Access Compliance Report

Public Rights-of-Way

(Curb Ramps)

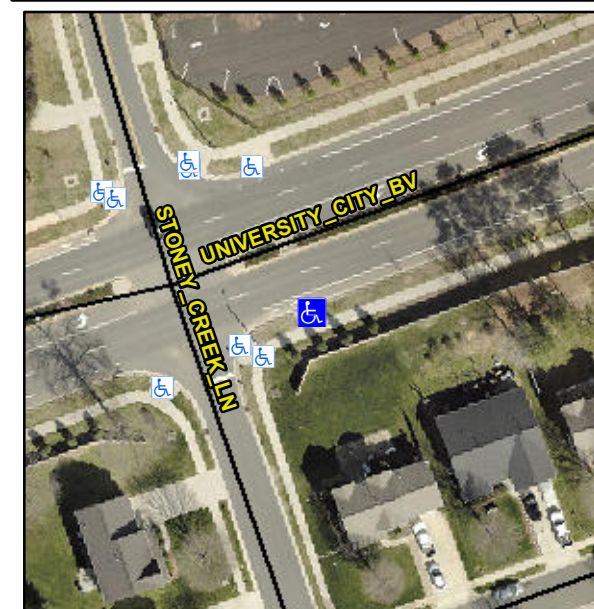
Intersection ID: 48587	Main Street: STONEY_CREEK_LN	Cross Street: UNIVERSITY_CITY_BV	Location: SW
ADA ID: B57F5FDC4380	Ramp Type: Perp	Initial Pass/Fail: Fail	Overall Compliance: No
Severity Score: 8.75			
Codes/Mitigation Info/Possible Solution		Field Measurements/Component Compliance

Not Found, R304.5.1

Compliance	Description	Data	Compliance	Description	Data
N/A	Ramp Length (in)	95.0	Yes	Ramp Slope (%)	7.4
No	Ramp Width (in)	47.0	Yes	Ramp XSlope (%)	0.1
N/A	Flare Type LT	N/A	N/A	Flare Type RT	N/A
N/A	Flare Slope LT (%)	N/A	N/A	Flare Slope RT (%)	N/A
N/A	Flare Traversable LT?	N/A	N/A	Flare Traversable RT?	N/A
N/A	Landing Length (in)	N/A	N/A	DWS Provided?	N/A
N/A	Landing Width (in)	N/A	N/A	DWS Contrast?	N/A
N/A	Landing Slope (%)	N/A	N/A	DWS Length (in)	N/A
N/A	Landing X Slope (%)	N/A	N/A	DWS Full Width?	N/A
N/A	Landing Curb? (Y/N)	N/A	N/A	DWS Offset (in)	N/A
N/A	Shared Landing?	N/A			
N/A	Gutter Ponding?	N/A	N/A	Gutter Slope (%)	N/A
N/A	Gutter Lip Ht (in)	N/A	N/A	Gutter X Slope (%)	N/A
N/A	Painted X Walk1?	No	N/A	Painted X Walk2?	N/A
	X Walk 1 Direction	To N		X Walk 2 Direction	N/A
N/A	X Walk 1 Width (in)	N/A	N/A	X Walk 2 Width (in)	N/A
	X Walk 1 Slope (%)	1.9		X Walk 2 Slope (%)	N/A
	X Walk 1 X Slope (%)	0.4		X Walk 2 X Slope (%)	N/A

N/A	Ramp inside XWalk1?	N/A	N/A	Ramp inside XWalk2?	N/A
	Road Slope (%)	N/A	N/A	Clear Space?	N/A
	Road X Slope (%)	N/A	N/A	Clear Space to XWalk (in)	N/A
N/A	Any Obstructions?	N/A	N/A	Storm Grate/Utility Hazard?	N/A
	Obstruction Type			Storm Grate/Utility Type	
		N/A			N/A
			Yes	Surface Condition? (G/P)	Good

Remove & Replace Entire Ramp.
